SUBJECT: C-8513 SR 167 Puyallup River Bridge – Bridge Replacement
Change Order No. 002 – Truss Repair

**WASHINGTON STATE
DEPARTMENT OF TRANSPORTATION
CHANGE ORDER**

CONTRACT NO: 008513 FEDERAL AID NO: BR-0167(047)
CONTRACT TITLE: SR 167, PUYALLUP RIVER BRIDGE - BRIDGE REPLACEMENT
CHANGE ORDER NO: 2 TRUSS REPAIR

INTERIOR ANGLE REPAIR PANEL POINTS L2 & L12	JOB NO. 13034J
SR 167 PUYALLUP RIVER BRIDGE STEEL TRUSS REPAIR	SHEET NO. S4

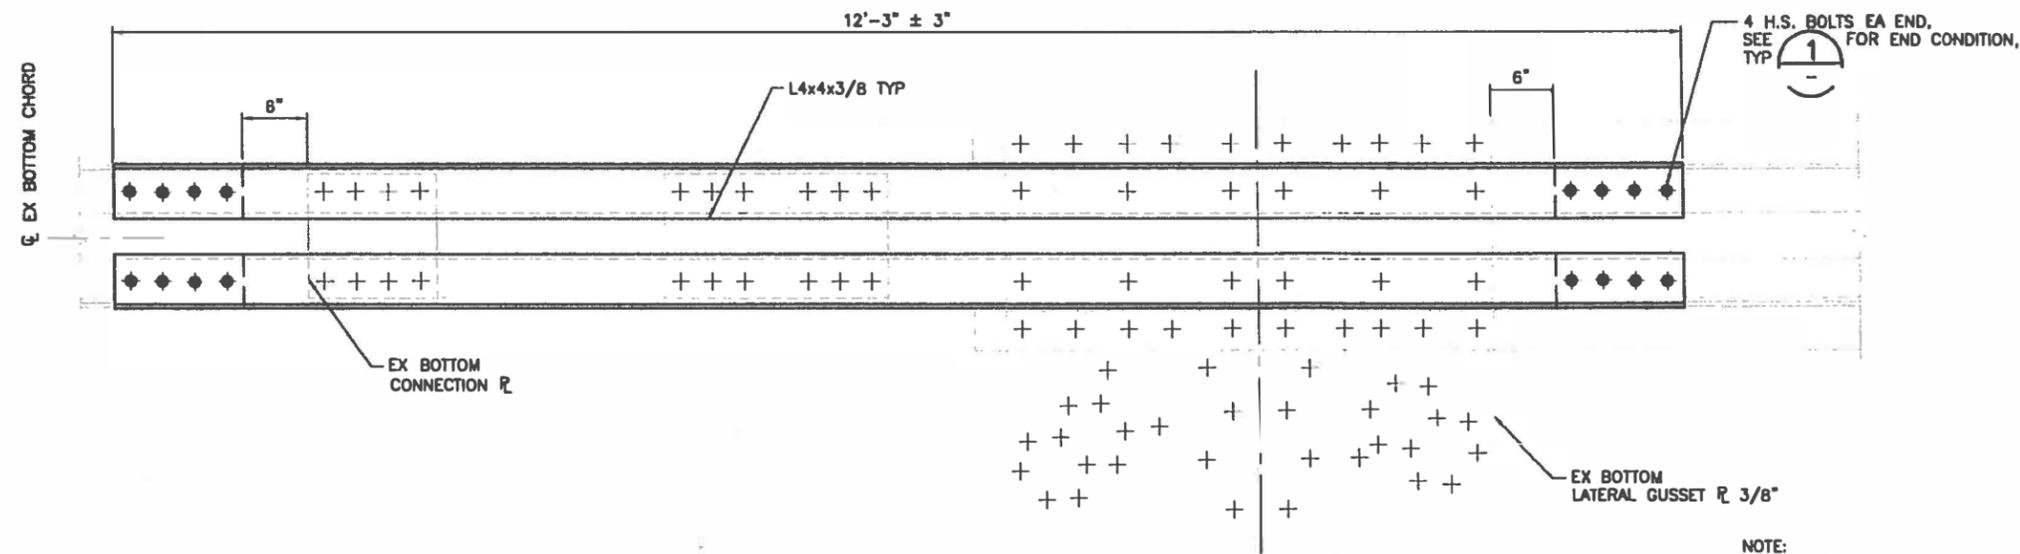
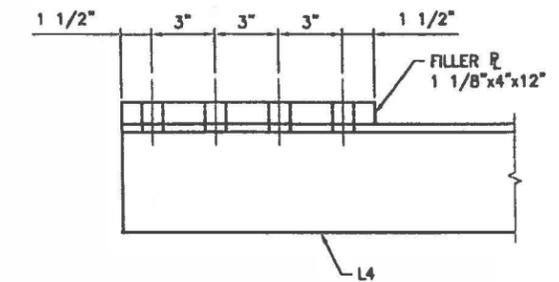
- 1) Replace section loss to the bottom chords interior Bottom Chord Angles for panels L0, L1, L2, L12, L13 and L14 of both the east and west truss.
- 2) Replace section loss to the interior and exterior Gusset Plates at L2 and L12 of both the east and west truss.
- 3) Replace missing bolts and sheared rivets on floor Stringers as identified in pages 5 and 10 of this change order.

NOTE:
 EXISTING CONDITION SHOWN ON THESE DRAWINGS SHALL BE VERIFIED IN THE FIELD. THE LENGTH OF THE ANGLE SHALL BE ADJUSTED TO FIT.
